Kitchen and Terrace for Old Oaks Country Club

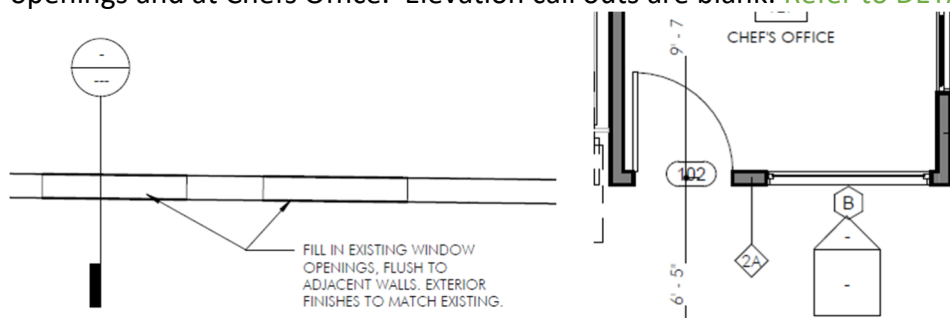
Who is doing logo on pavers #2? By Contractor.

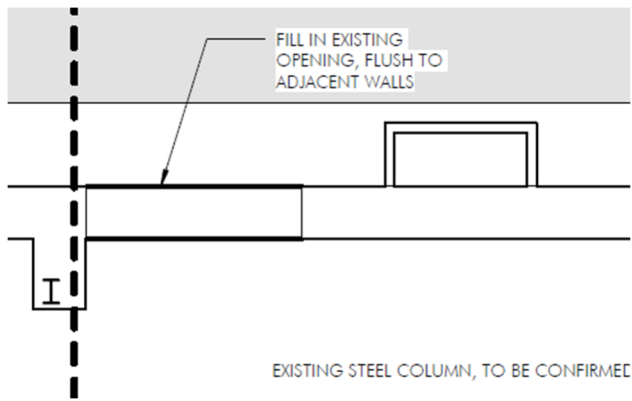
9. A102.00 – Please provide Kitchen Consultant Drawings and Bar Consultant Drawings for reference. **See link attached to the email.**
10. A101.00 - Please provide missing sections/elevations for wall infill at existing window openings and at Chefs Office. Elevation call outs are blank: **Refer to DETAIL ON SK-01**

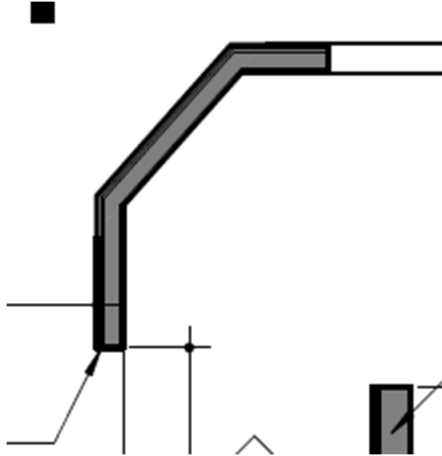
11. A101.00 - Please advise partition type for wall infill at Dining Room side: **Fill Existing Wall in Kind. Install new finish, chairrail, wall base and wall panels to match existing in the dining room, in style and color.**

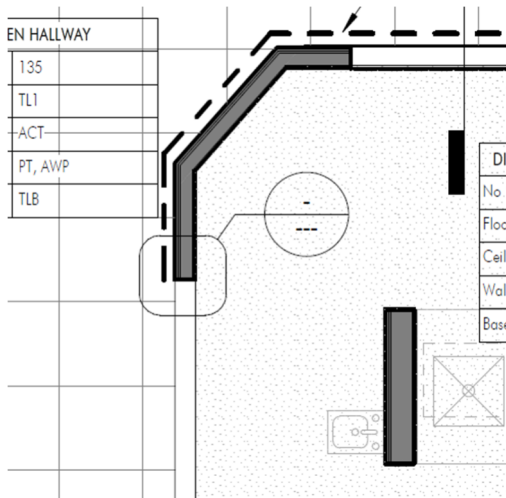
12. A-101 – Please advise partition type at Washing Room 129, wall not tagged: [Refer to Partition Type 2 on G100 and Section 5/A120.](#)

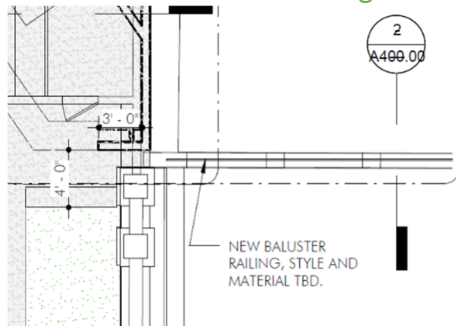
14. A108.00 - Note indicates finish is TBD for new trench drain. Please advise finish required. [Stainless Steel.](#)

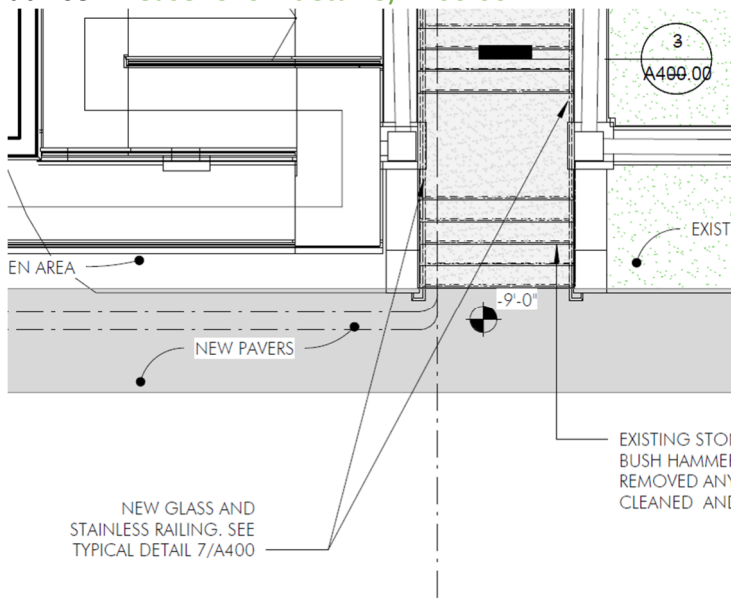
16. A108.00 – Drawings calls for “existing railing, balusters, and posts to be repaired, typ.”. Please advise scope of work, or allowance for GCs to carry. **Please provide allowance of \$25,000 for repairing and cleaning of existing railing.**
17. A108.00 – Please provide specifications for cleaning requirements, stain removal & refinishing of existing stone. **Existing stone steps to be bush hammered or sand blasted to removed stains. No need for other surface treatment afterwards.**
18. A108.00 – Please clarify what railings are required – plan includes two different details at terrace stairs – Detail 3/A400.00 which includes a stainless-steel handrails & posts and Detail 7/A400.00 which includes a stainless-steel cap and glass partition. Please advise. **Please follow detail 3/A400.00**
